Access Compliance Report

Public Rights-of-Way

(Curb Ramps)

Intersection ID: N/A	Main Street: WAVERLY_WALK_AV	Cross Street: HONEYMEADE_CIR	Location: NE
ADA ID: 446FAD4B7B60	Ramp Type: Perp	Initial Pass/Fail: Fail	Overall Compliance: No
Codes/Mitigation Info/Possible Solution		Field Measurements/Component Compliance	
Severity Score: 12.5

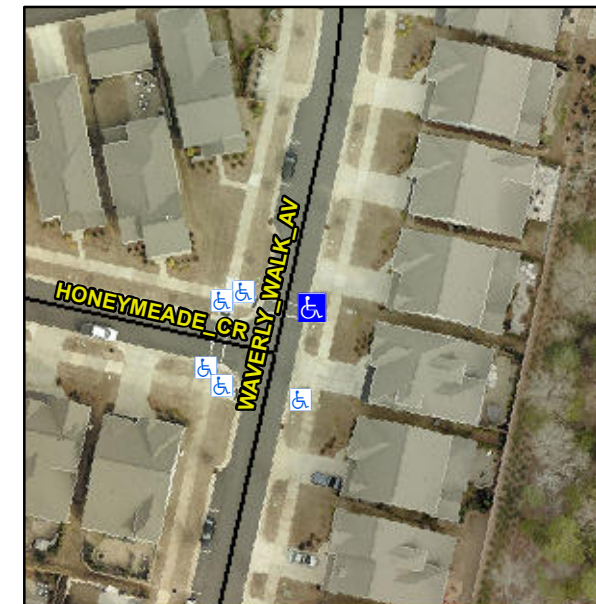
Not Found, R304.2.2

Compliance	Description	Data	Compliance	Description	Data
N/A	Ramp Length (in)	95.0	No	Ramp Slope (%)	9.4
Yes	Ramp Width (in)	72.0	Yes	Ramp XSlope (%)	1.4
N/A	Flare Type LT	N/A	N/A	Flare Type RT	N/A
N/A	Flare Slope LT (%)	N/A	N/A	Flare Slope RT (%)	N/A
N/A	Flare Traversable LT?	N/A	N/A	Flare Traversable RT?	N/A
N/A	Landing Length (in)	N/A	N/A	DWS Provided?	N/A
N/A	Landing Width (in)	N/A	N/A	DWS Contrast?	N/A
N/A	Landing Slope (%)	N/A	N/A	DWS Length (in)	N/A
N/A	Landing X Slope (%)	N/A	N/A	DWS Full Width?	N/A
N/A	Landing Curb? (Y/N)	N/A	N/A	DWS Offset (in)	N/A
N/A	Shared Landing?	N/A			
N/A	Gutter Ponding?	N/A	N/A	Gutter Slope (%)	N/A
N/A	Gutter Lip Ht (in)	1.0	N/A	Gutter X Slope (%)	N/A
N/A	Painted X Walk1?	No	N/A	Painted X Walk2?	N/A
	X Walk 1 Direction	To NW		X Walk 2 Direction	N/A
N/A	X Walk 1 Width (in)	N/A	N/A	X Walk 2 Width (in)	N/A
	X Walk 1 Slope (%)	2.2		X Walk 2 Slope (%)	N/A
	X Walk 1 X Slope (%)	0.8		X Walk 2 X Slope (%)	N/A

Remove & Replace Entire Ramp.
